Seattle Center Arena

Project Description

Meeting Summary

This was the Seattle Design Commission's (SDC) fifth review of the Seattle Center Arena Project. The purpose of this meeting was to review the design development (90% design) for the project. After the presentation and discussion the SDC voted, 5-0, to approve the design development phase with several conditions and recommendations.

Figure 1: South parcel site plan

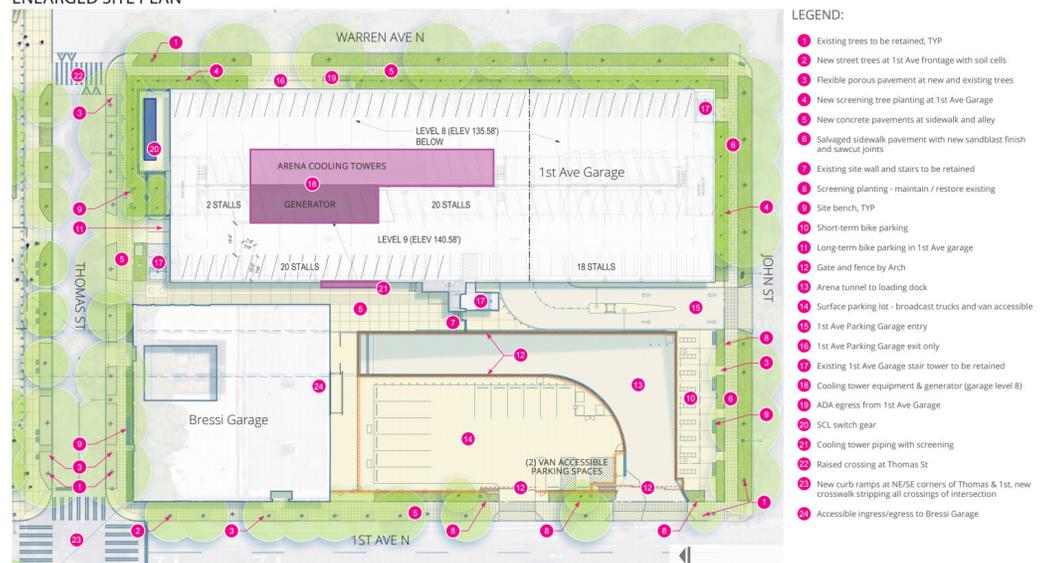
The SDC then commented on the switchgear located adjacent to the existing parking garage. Commissioners appreciated the relocation of the switchgear below grade along Thomas Street. The Commission agreed this was a positive change for the surrounding area. The SDC then expressed their concern with the quality and durability of the proposed screening materials for the cooling tower. The Commission conditioned that the project team show how the proposed materials have been refined in response to reevaluating long term sustainability and durability of the screening material.

The SDC appreciated the scale of the pedestrian lighting, but recommended the project team include pedestrian lighting near the bike area on the south parcel as a way to increase the public's awareness of the bike area.

The SDC acknowledged the lack of visual hierarchy with the proposed materials, texture, and color palette. Commissioners encouraged the project team to use materials with a greater variety of textures and colors to help create a hierarchy and to add depth within the open space. The Commission then reiterated their concern over the long term sustainability and durability of the screening material on the south parcel.

Commissioners are concerned the specified material will deteriorate much faster than anticipated and recommended the project team consider an alternative material.

1. Return to the SDC for a subcommittee review of the curb management plan that shows integration of different transportation modes as well as better integration with the surrounding site¹
2. Show how the proposed materials of the garage rooftop cooling towers have been refined to address concerns about their long-term sustainability and durability²
3. Revisit the art integration plan to ensure art is well integrated with site and enhances experience on site, specifically near signage³

Figure 3: Updated site plan

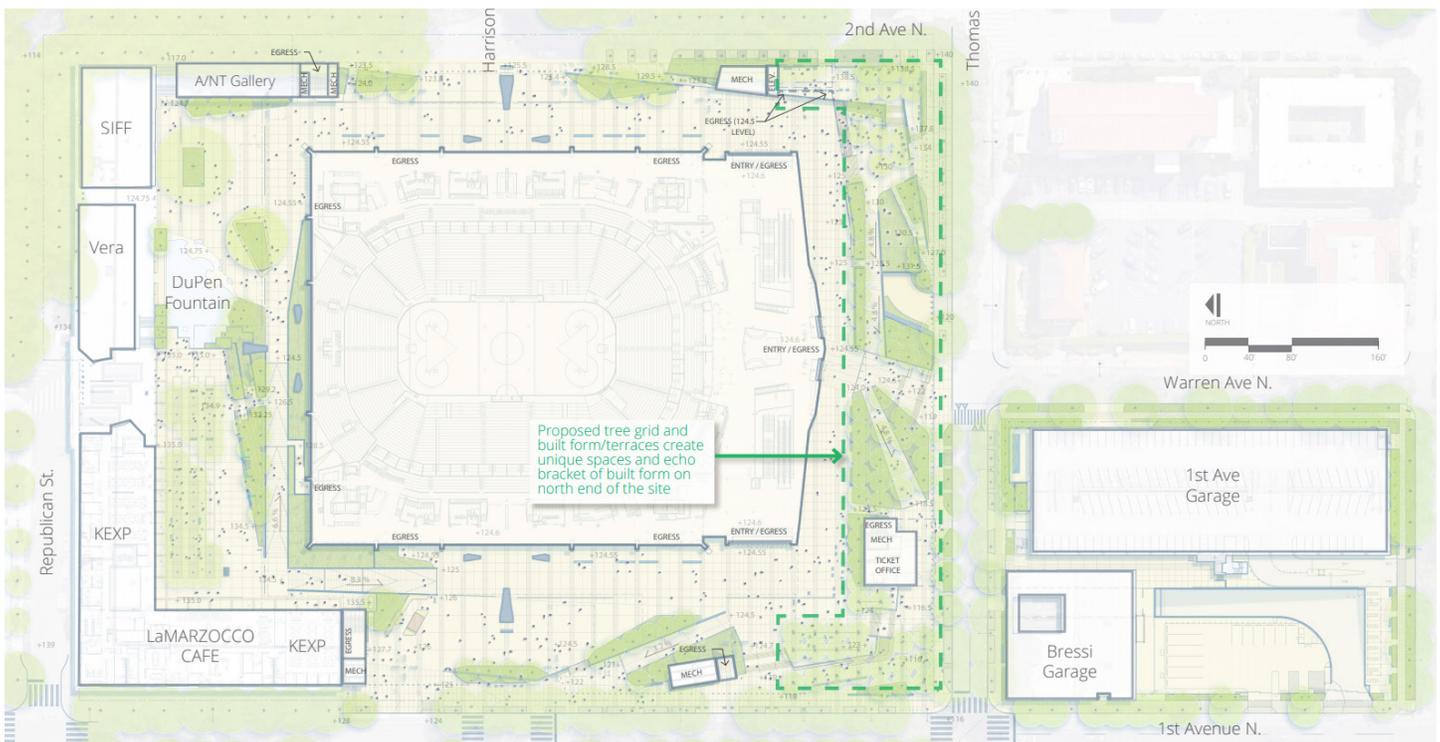
The SDC appreciated the project team's response as to why a curbless design could not be implemented on Thomas Street. The Commission also appreciated the project team identifying Thomas Street as a pedestrian space and recommended they continue to prioritize pedestrian movement across Thomas Street. Commissioners then encouraged the project team to continue prioritizing the protection of trees along Thomas Street.
